**SECTION 00 9111
ADDENDUM NUMBER ONE**

DATE: JULY 28, 2025

PROJECT: IOWA STATE FAIR – SWINE-CATTLE BARN UPDATES – PHASE 1

ARCHITECT: KEFFER/OVERTON ARCHITECTS

A102-1

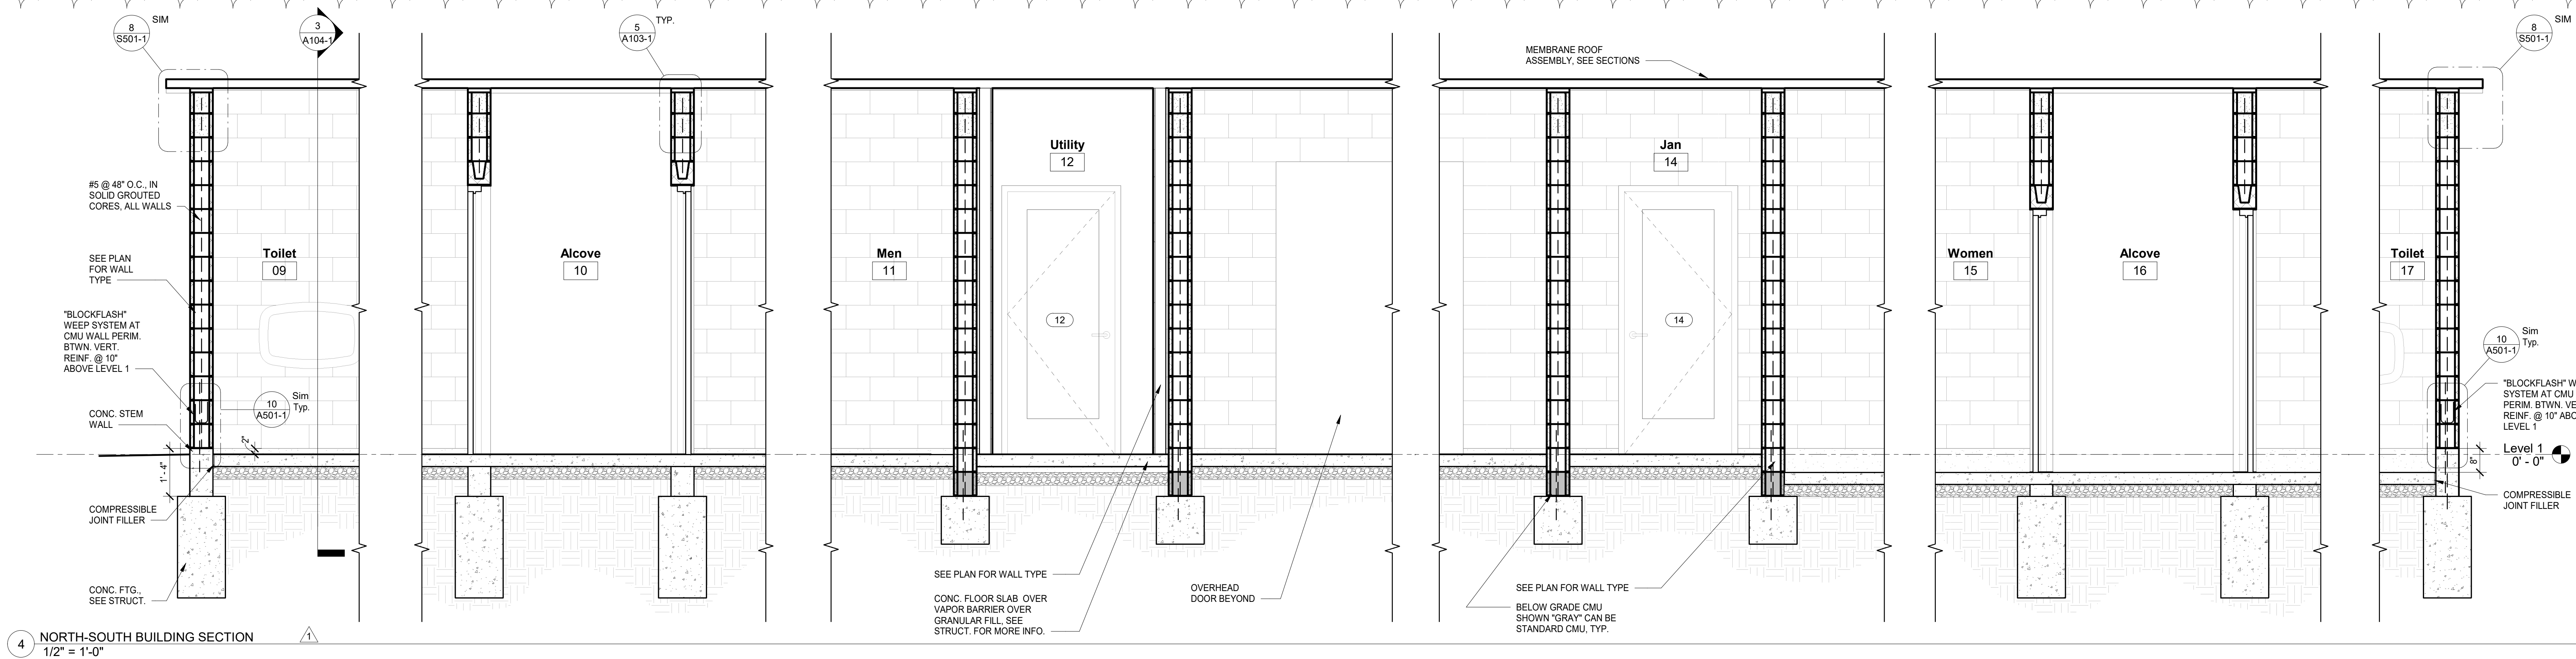
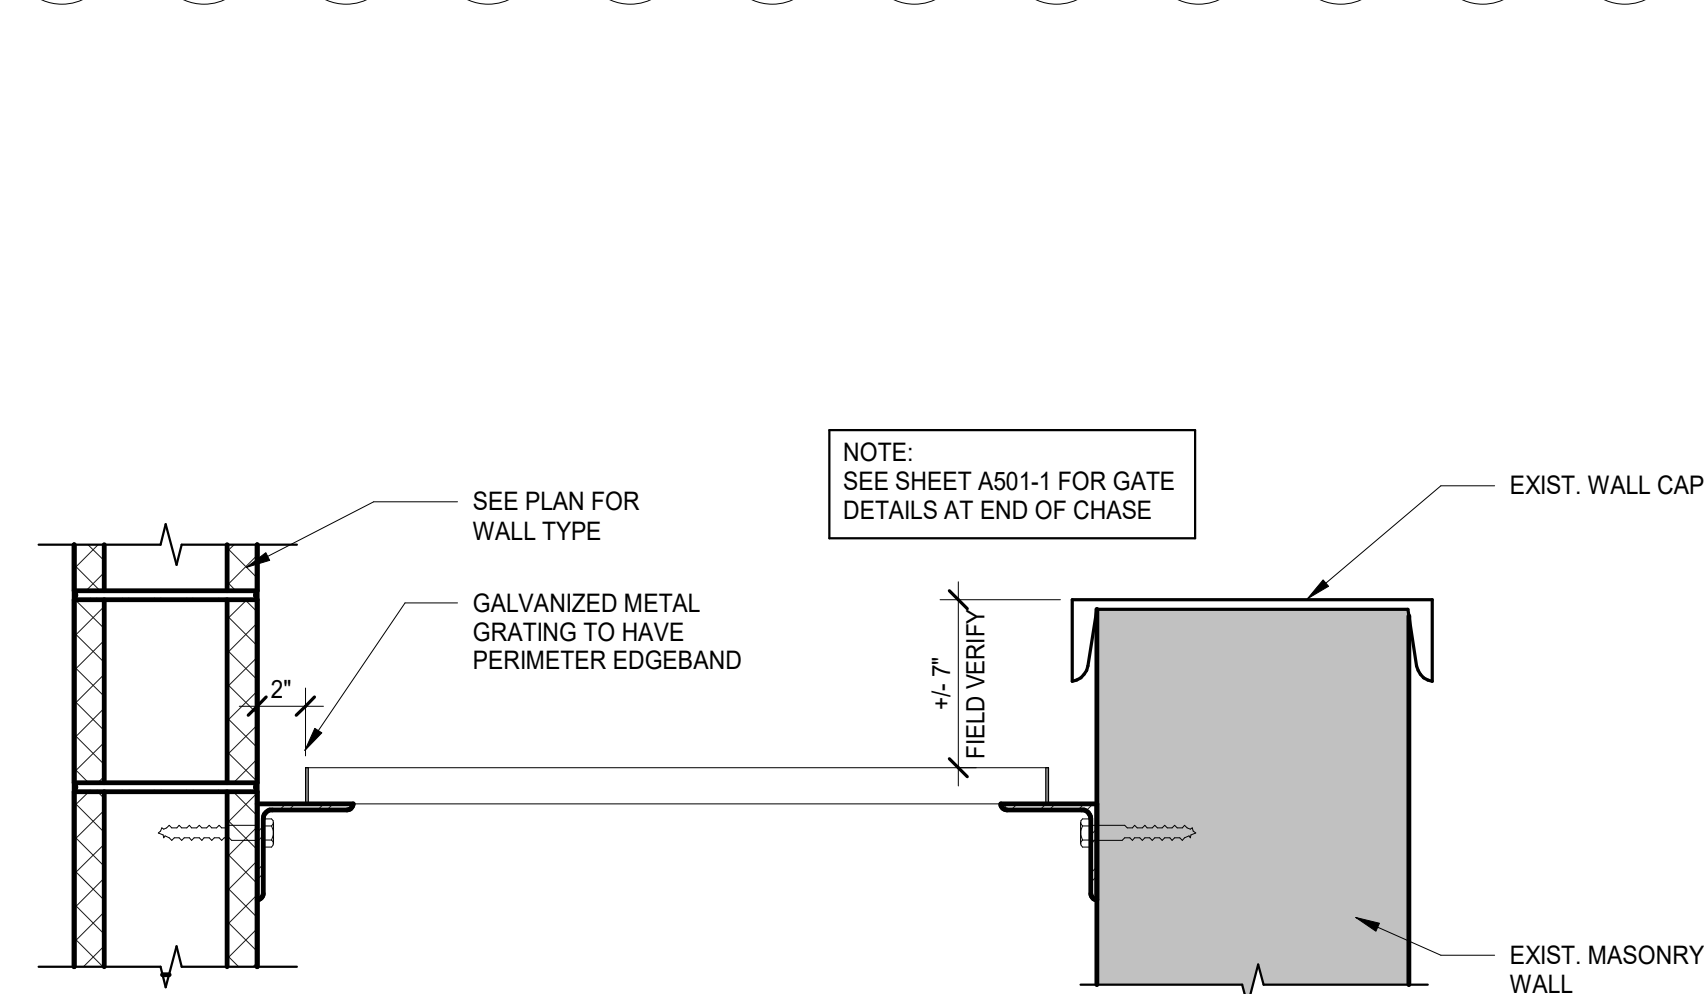
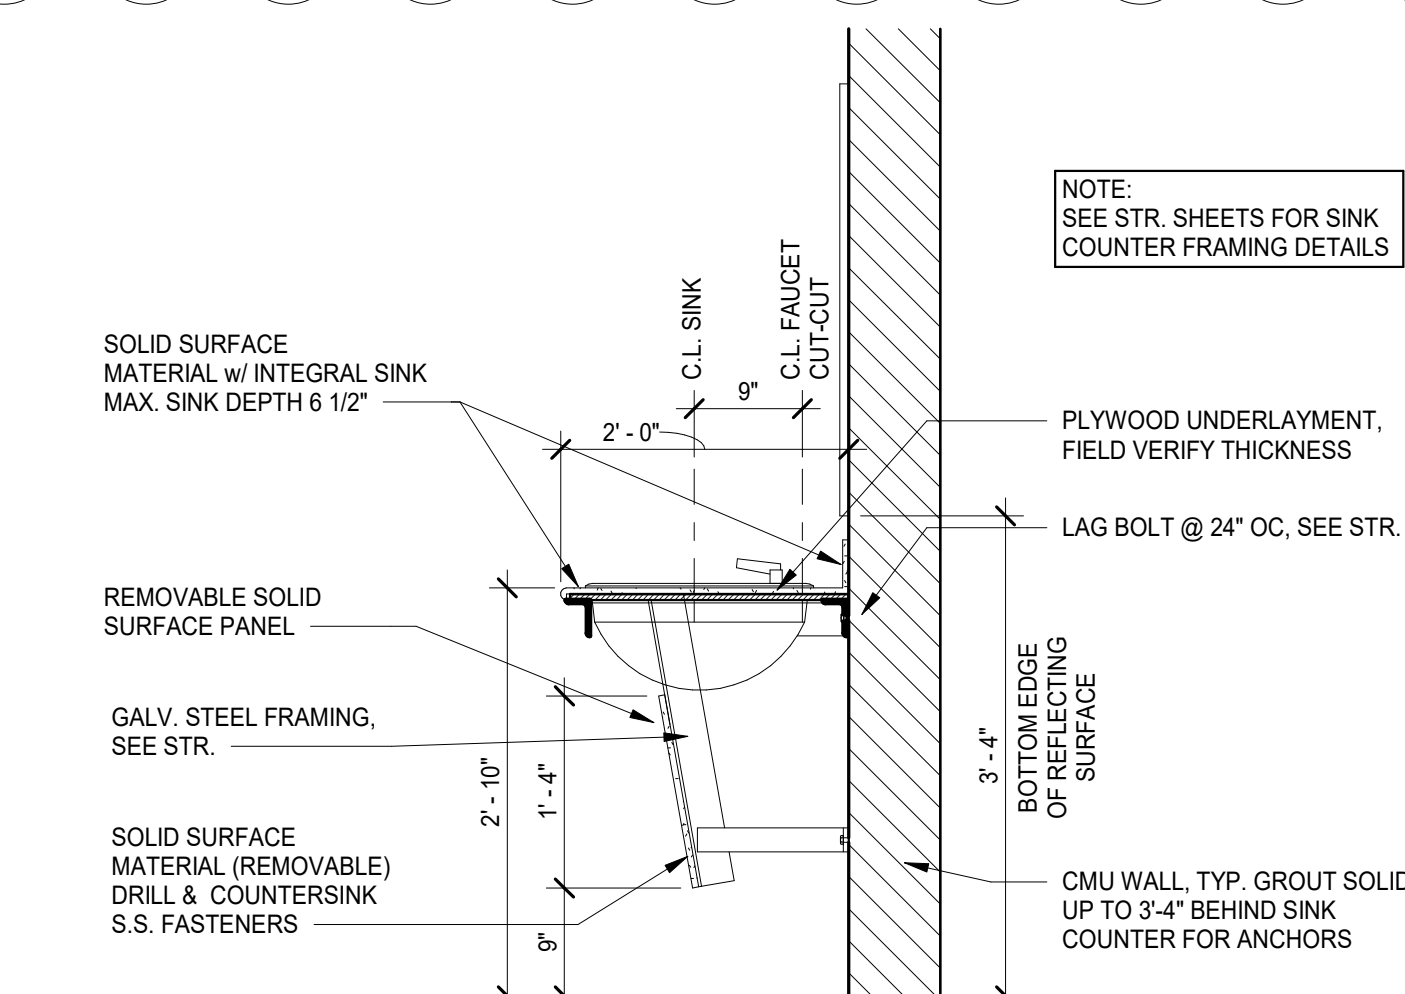
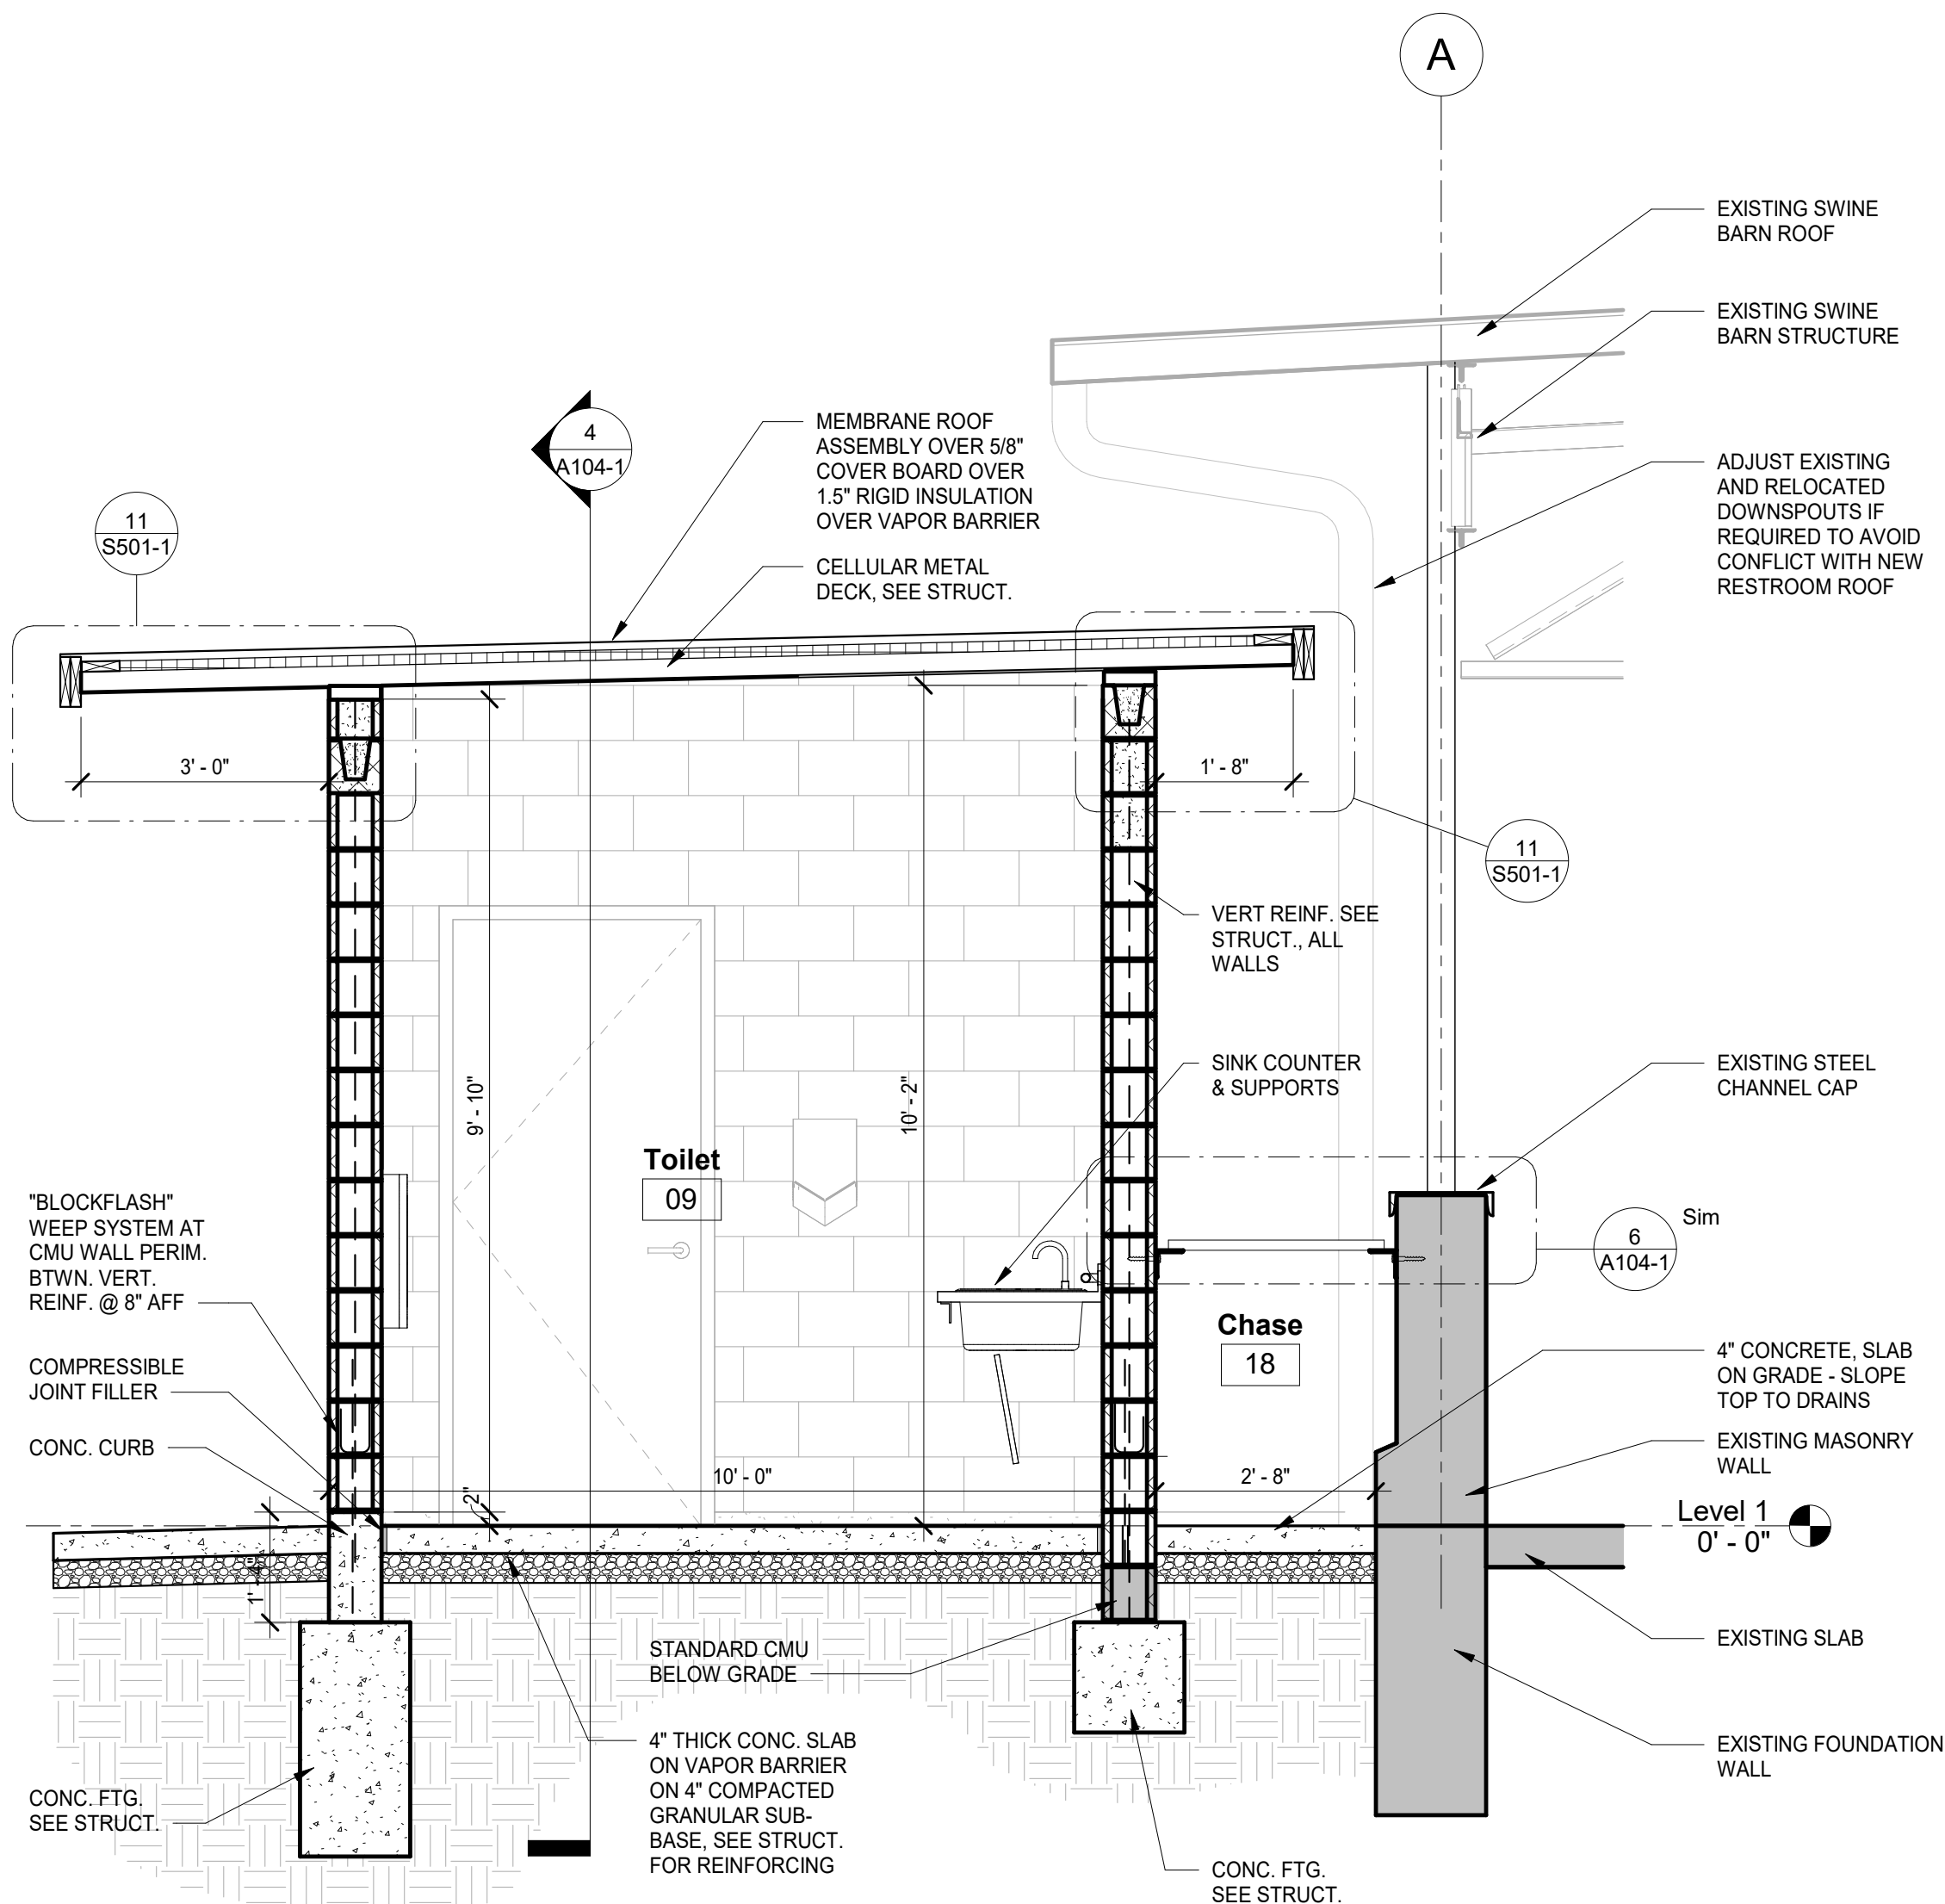
- B. SHEET A102-1 – ENLARGED RESTROOM PLANS (Refer to revised sheet.)
 - 1. Detail 2. Phase 1 – Enlarged Demo Floor Plan. Replace this floor plan in its entirety as shown on Attachment A102-1.

- 2. Detail 3. Modify extents of concrete floor slab between rooms as shown on Attachment A102-1.
 - 3. Detail 4. Add note pointing to column in Men's Room 11 as shown on Attachment A102-1.
